3.3 Fresh thinking for the site

3.4 Pre-App 1 Scheme | 11.11.19

3.11 Design Review Panel comments and the Design Response

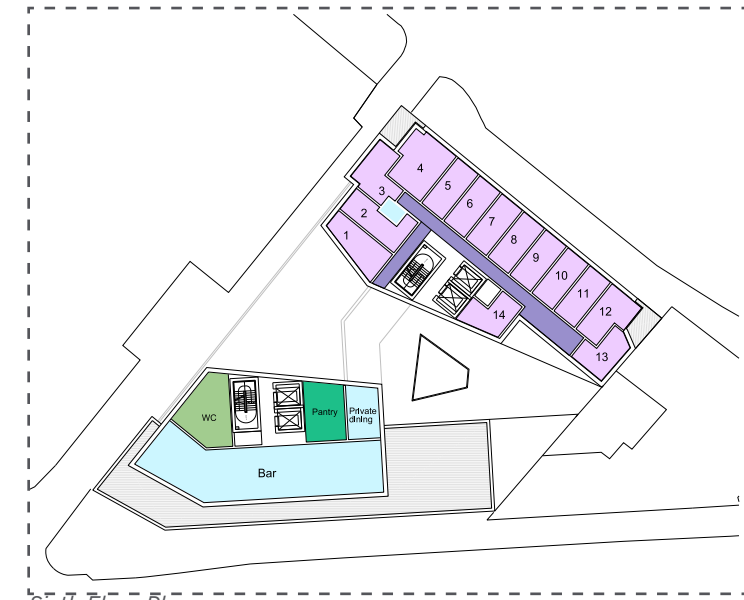
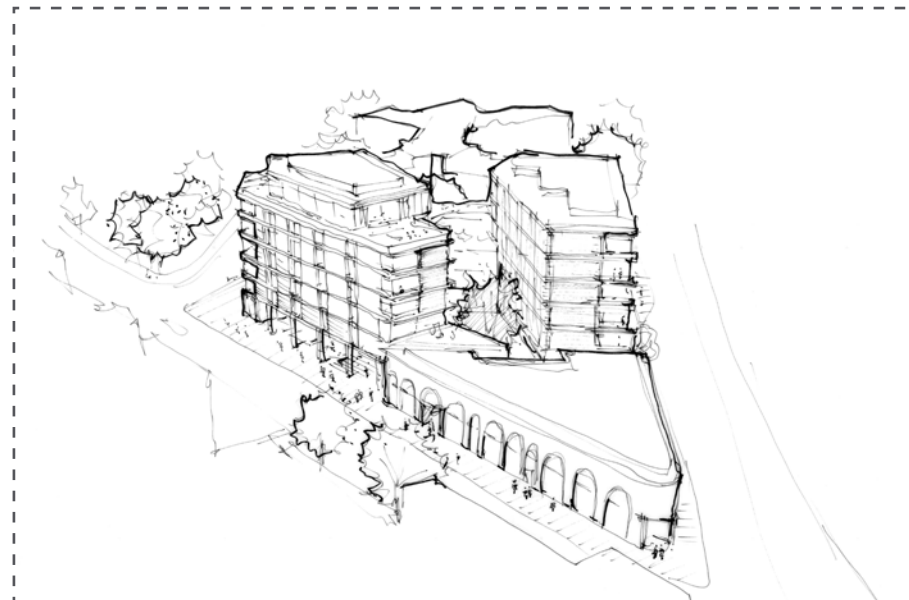
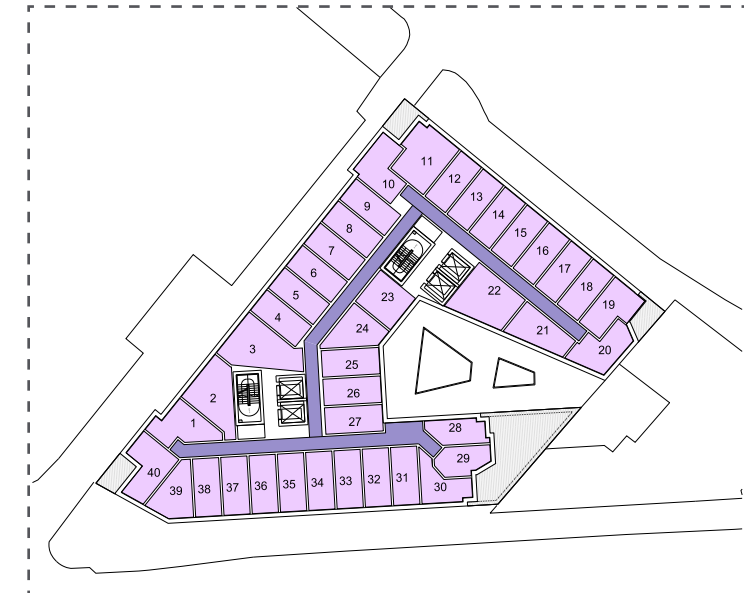
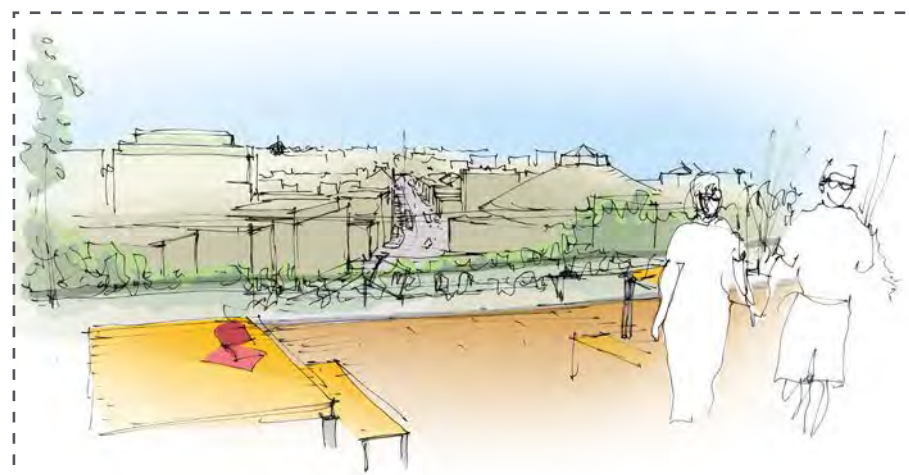
LB Camden's main comments were as follows:

- Site is an identified housing site due to consented scheme;
- Loss of affordable housing would be viewed negatively;
- Change of use (to hotel) would need to be justified by betterment of the consented affordable housing provision;
- LB Camden confirmed they will not support 100% hotel but will support a mixed use scheme with approximately 50% residential and 50% hotel. A mixed-use scheme should be 50% residential (Local Plan policy E3);
- Loss of residential would need to be justified via a package of benefits.

3.5 Pre-App 2 Scheme | 12.12.19

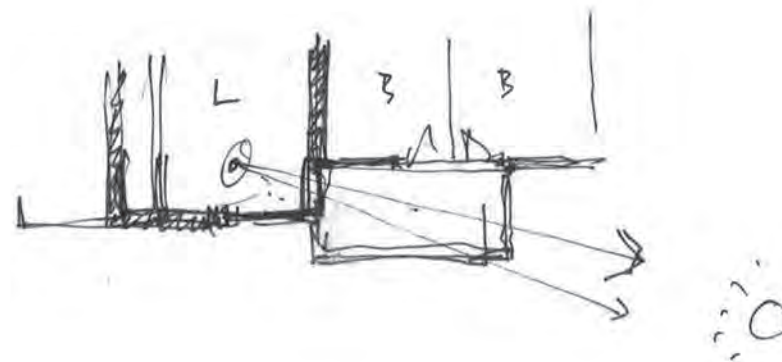
LB Camden's main comments were as follows:

- LB Camden confirmed they will not support 70% hotel and 30% residential but they will support a mixed use scheme with approximately 50% residential and 50% hotel;
- Hotel use not contentious if policy compliant land use for residential (50% affordable) is proposed;
- Non-policy compliant scheme might be acceptable if affordable housing provision is an improvement over the consented scheme (e.g. by amending the tenure split);

3.10 Design Review Panel Scheme | 11.09.20

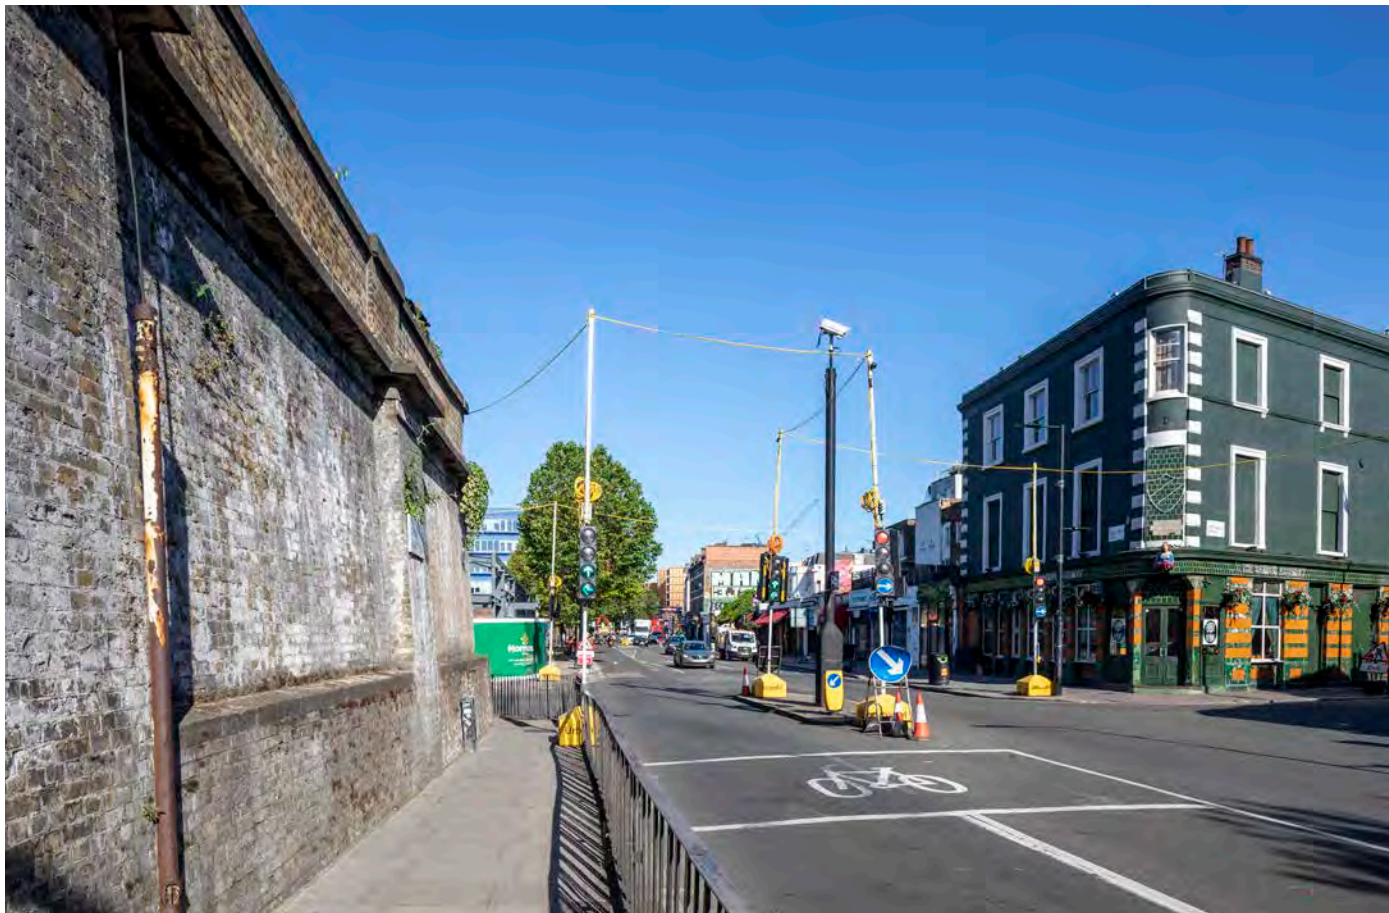
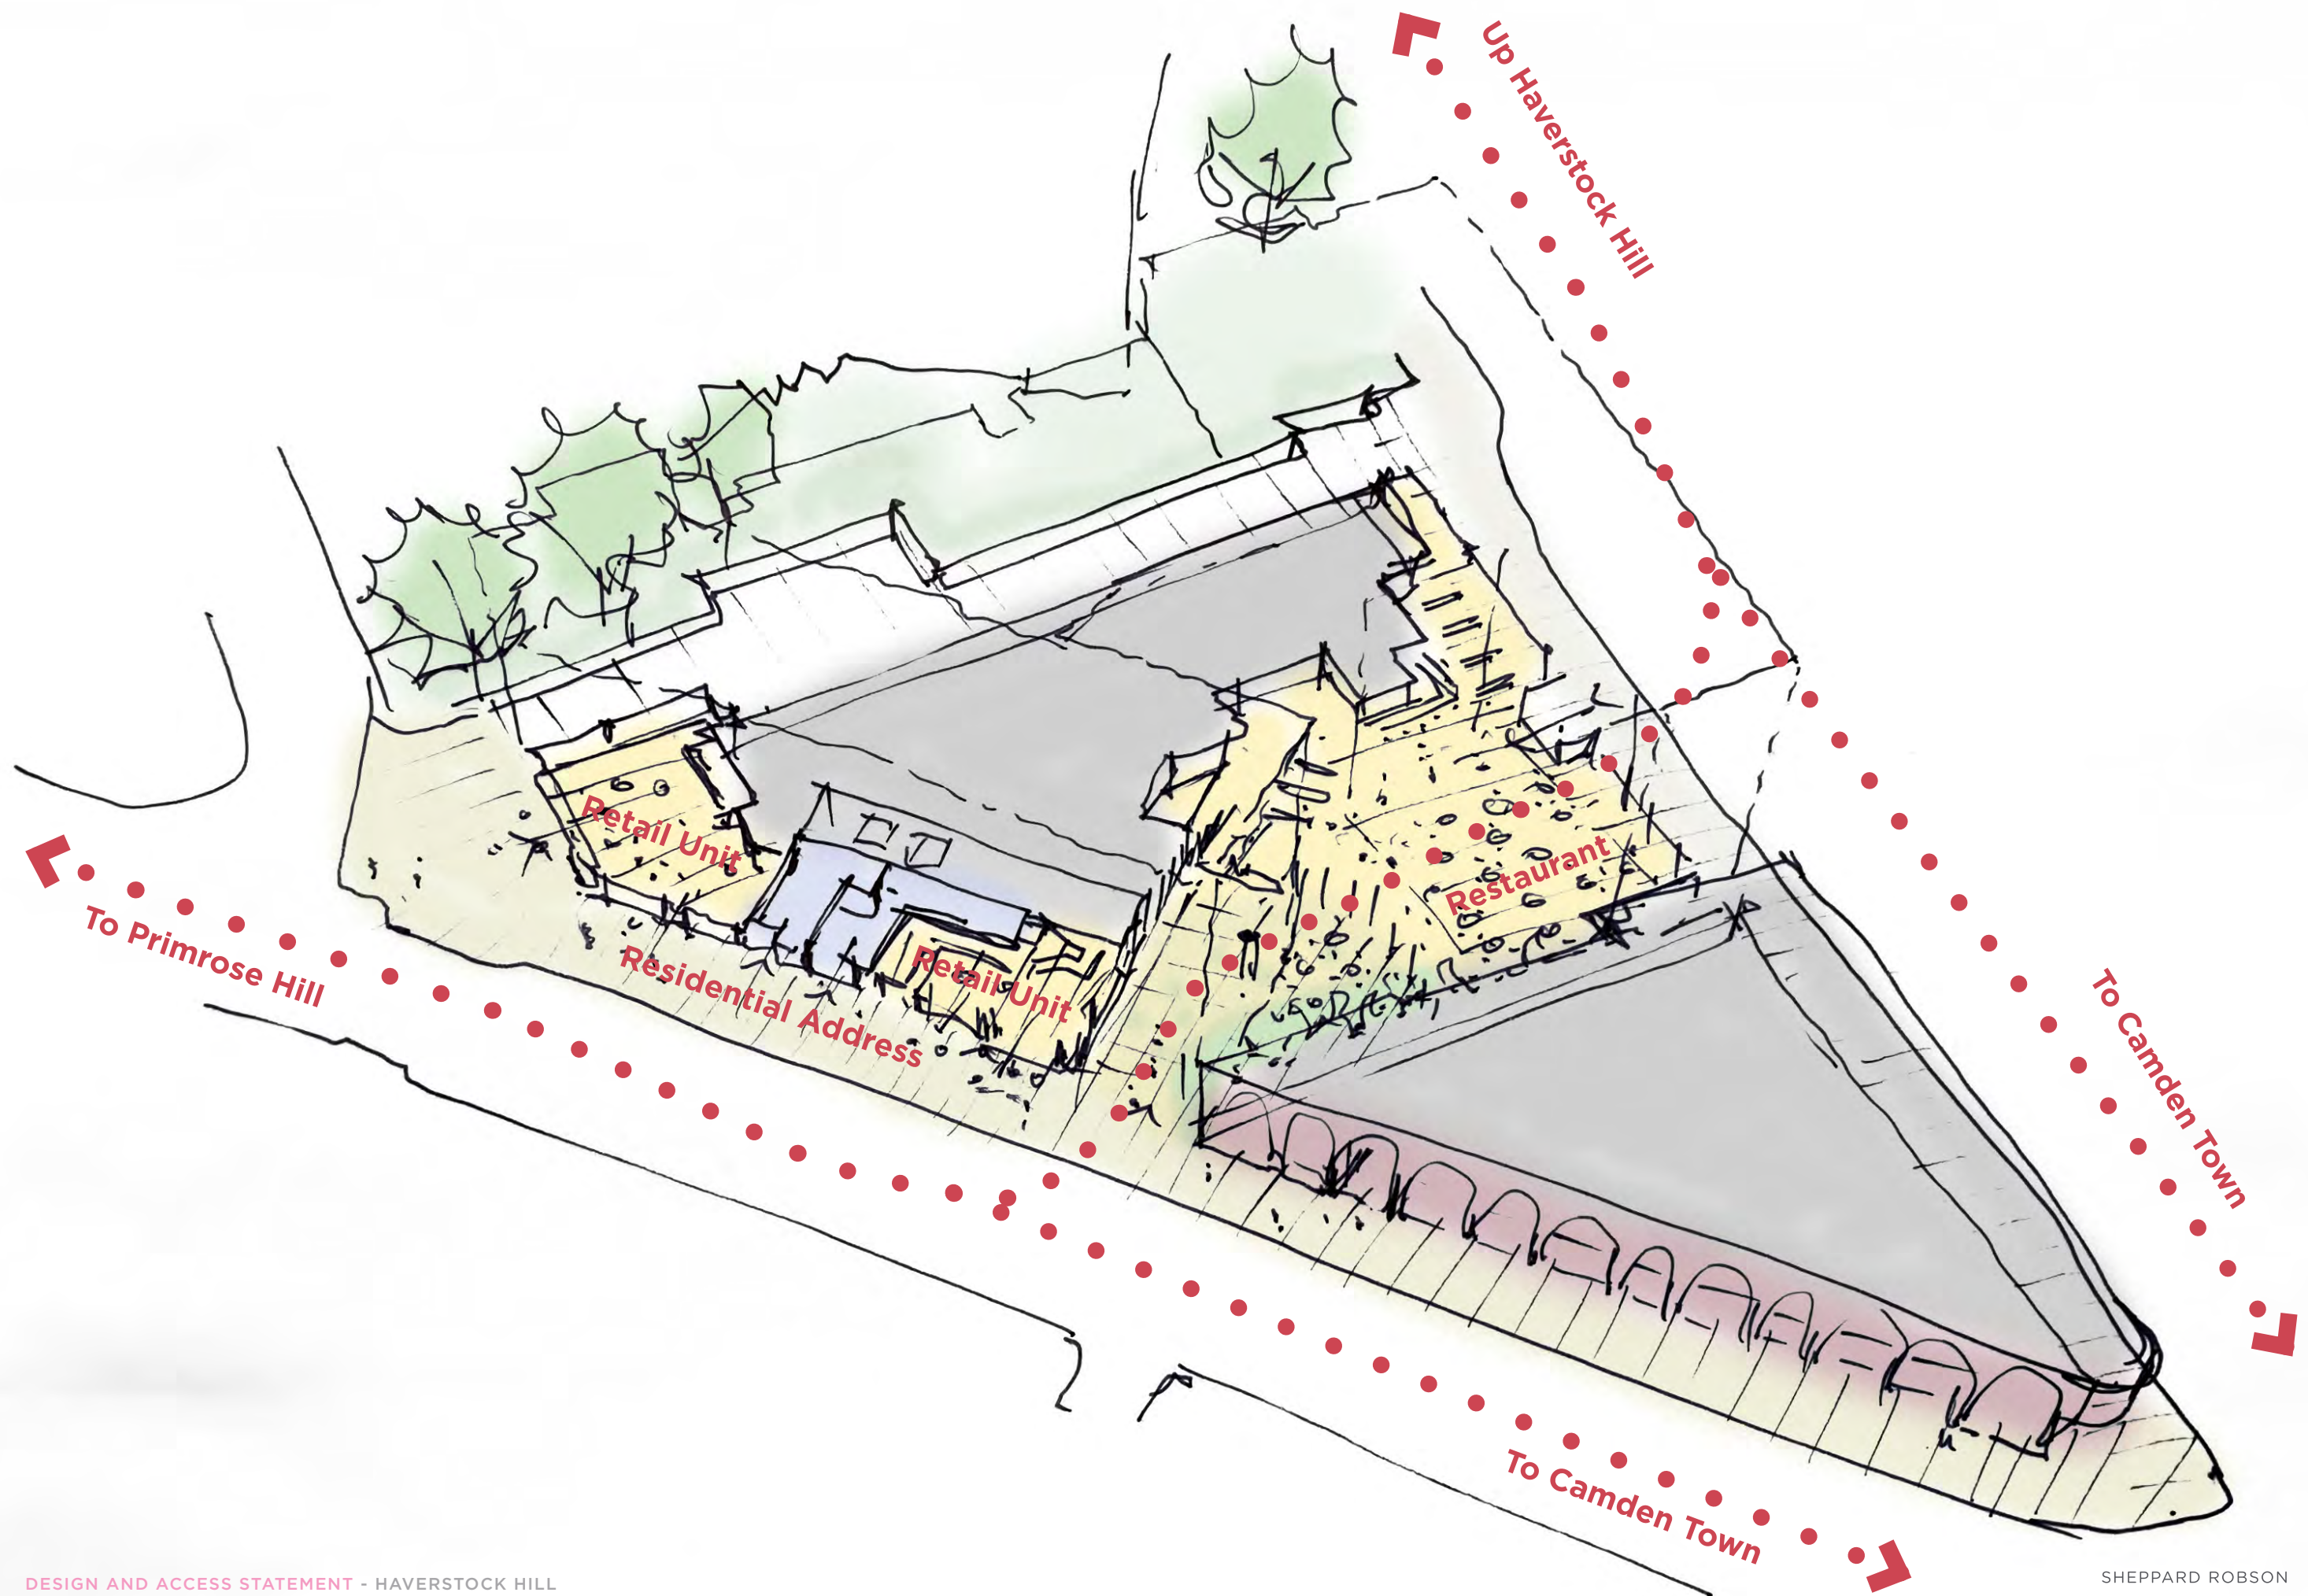
- The panel considers that the building requires a clearer design narrative that treats the hotel and residential buildings and the station as three distinct elements within a block.

- The massing at the centre of the site, between the buildings fronting onto Adelaide Road and Haverstock Hill, appears confused. The view from Chalk Farm Road would be improved if this element were set below and / or further back from the adjacent hotel wing.

- The gable ends rising above Chalk Farm Station appear too dominant, an impression created partly by wider areas of blank brick wall than the consented scheme.

- The design should be developed to create a slimmer

impression in views from Chalk Farm Road. This could include opening up the gable corner of the hotel building, and providing a clearer distinction between the inner and outer elevations of each block.

- The panel suggests that the architectural language should differ more between the residential and hotel blocks, to distinguish between their functions. They currently appear very similar, and it not immediately apparent that they are not both commercial buildings.

- The panel suggests that the elevations on Haverstock Hill and Adelaide Road both appear complicated in comparison to Chalk Farm Station, and that the amount of variation in stepping and texture should be reduced.

- Further work is needed to ensure a clear relationship between the banding on both elevations, and the strong cornice line of the station building.
 - » **RESPONSE:** Please refer to sections 4.6 and 4.7. The horizontal cues from the station (cornice line, horizontal banding over the arches) have been used to order the ground levels of the Harverstock Hill and Adelaide Road elevations.

- The expression of the datum line on the block facing Haverstock Hill is more convincing than that on Adelaide Road. Here it is compromised by the insertion of an additional floor beneath.

- The junction between the residential building on Adelaide Road and the station building is uncomfortable, with the edge of the proposed building defined by balcony railings. The panel suggests this is refined, and the building potentially set back from the station at first and second floor levels.

- The panel feels that ‘Tecu’ brass is too commercial a material for a residential block, and the colour it introduces is not an appropriate response to the listed Chalk Farm Station next

door.

- The panel likes the soft red brick proposed and the reconstituted stone banding, which relate well to the colouring of the underground station.
- Additional analysis of the underground station palette and detail could provide further cues for the material approach.
 - » RESPONSE: Please refer to section 5.4. The material palette of the proposal has been carefully selected to be a complimentary response to the station. A mix of salmon toned, handmade bricks, dark scarlet and merlot glazed terracotta and charcoal grey metal.

- The panel welcomes the relationship created between ground retail and café space and the street and feel this will enhance the activation of the area.
 - » RESPONSE: Please refer to section 7.1. The area of the courtyard has been increased to allow the mass of the blocks to come uninterrupted to ground.
- More work should be done to reduce the number of single aspect units in the development.
 - » RESPONSE: Please refer to sections 4.6 and 4.7. The residential layouts have been redesigned to maximise the number of double and triple aspect units.
- The panel is particularly concerned by the quality of single aspect units on the third floor, which are likely to be dark. Two units have deep, north-west facing balconies, and

another overlooks the courtyard. The latter also has an awkward entrance through the kitchen space. It asks that options are assessed to improve the quality of these units.

- The panel also suggests that the angling of windows to the residential units should be refined to ensure they are positioned in the most effective way and relate to the internal layout of the units.

- The activation of the ground floor on Haverstock Hill will be very beneficial to the area. The panel asks whether the

pavement area outside the entrance to the restaurant could be made even wider, to create as generous as area of public realm as possible.

- The panel suggests more opportunities should be taken to plant new trees around the site boundary to help achieve the required urban greening factor
 - » RESPONSE: Please refer to section 7.3 and 7.4. The opportunity for new tree planting has been identified in the courtyard and the rooftop amenity space.

- This could include filling gaps in the avenue of trees along the Haverstock Hill, planting trees at the entrance to the new building, and a large tree at the south-west corner of the site on Adelaide Road.

- The panel cautions against the inclusion of a green wall in the courtyard. It would be simpler and cheaper to grow ivy on the party wall with Chalk Farm Station.

- » **RESPONSE:** Please refer to section 4.1. The residential and hotel buildings are now distinct elements within the block separated by a lower linking building. The buildings have clearly defined profiles and aspects but share a common architectural and material language that has been adapted to their respective uses. The residential building has wide inset balconies that order the facade while the hotel building has a more regular and symmetrical tripartite structural expression.

- » **RESPONSE:** Please refer to section 4.3. The massing of the blocks has been simplified and refined to present a clear definition as seen from Chalk Farm. this has been achieved by reducing the length and mass of the internal bar of the hotel.

- » **RESPONSE:** Please refer to section 4.3. The gable ends have been redesigned to have a strong compositional order based around a solid vertical element on the one-third line and open, glassy corners that strengthen the reading of the horizontal lintels.

- » **RESPONSE:** Please refer to section 4.3. See response above. The corners of the gable ends are now glassy with a wider expression facing outwards to the streets.

- » **RESPONSE:** Please refer to sections 4.6, 4.7, 5.5 and 5.6. The buildings have clearly defined profiles and aspects but share a common architectural and material language that has been adapted to their respective uses. The residential building has wide inset balconies while the hotel building has a more regular and symmetrical tripartite structural expression.

- » **RESPONSE:** Please refer to sections 4.6 and 4.7 Careful attention has been given to define key vertical and horizontal relationships based on the order of the station frontages. The station has slightly different aspects on both roads; more symmetrical on Haverstock Hill, longer and based on tripartite bays on Adelaide Road. These orders have informed the respective façades of the proposal. There are strong horizontal cues from the station (cornice line, horizontal banding at the top of the arches) that have been keyed into to organise and clarify the lower levels of both façades. The ground levels on both street frontages have regular,

rectangular bays that reference the arched language of the station.

- » **RESPONSE:** Please refer to sections 4.6 and 4.7. The ground level order of the Adelaide Road frontage has been clarified to key more directly into the station language.

- » **RESPONSE:** Please refer to section 4.7. The mass of the residential block has been cut back to respond to and receive the station mass. An expressive canopy defines the entrance to the courtyard while expressly linking the two buildings.

- » RESPONSE: Please refer to section 5.4. The brass has been replaced as a highlight material by single or double fired glazed terracotta in tones that reference the ox-blood red glazed bricks of the station.

- » RESPONSE: Please refer to sections 8.9 and 8.10. No social rented flats overlook the courtyard from the living spaces/balconies. The unit referenced has been redesigned to be dual aspect.

- » RESPONSE: Please refer to sections 8.9 and 8.10. The facade and internal layouts of the units have been coordinated to optimise internal area.
- It is essential that residential units are designed with enough amenity and play space. The panel emphasises the need to ensure the quality of life created for residents, particularly children.

- » RESPONSE: Please refer to section 7.3. A generous play area, exceeding London Plan and Camden requirements has been provided at Level 05.
- Rather than creating a blank space on the boundary with Chalk Farm Station, the courtyard could be activated by wrapping more of the internal hotel space around the party wall.

- » RESPONSE: Please refer to section 7.4. The courtyard space has been increased. The aforementioned party wall will have built-in seating and planters.

- » RESPONSE: Please refer to section 8.2. The ground level is given over predominantly to retail and restaurant frontages with large expanses of glazed shop-fronts that can be potentially be opened onto the pavement.

- » RESPONSE: This potential will be explored with the Borough and highway authorities but must be coordinated with underground services.
- The gable ends rising above Chalk Farm Station may benefit from the addition of greenery. Climbers could be grown on the elevation, and maintained from the courtyard space using a cherry-picker.

- » RESPONSE: Fire regulations regarding fire spread on external envelopes prohibit the integrated growing of vegetation on residential buildings over 18m.
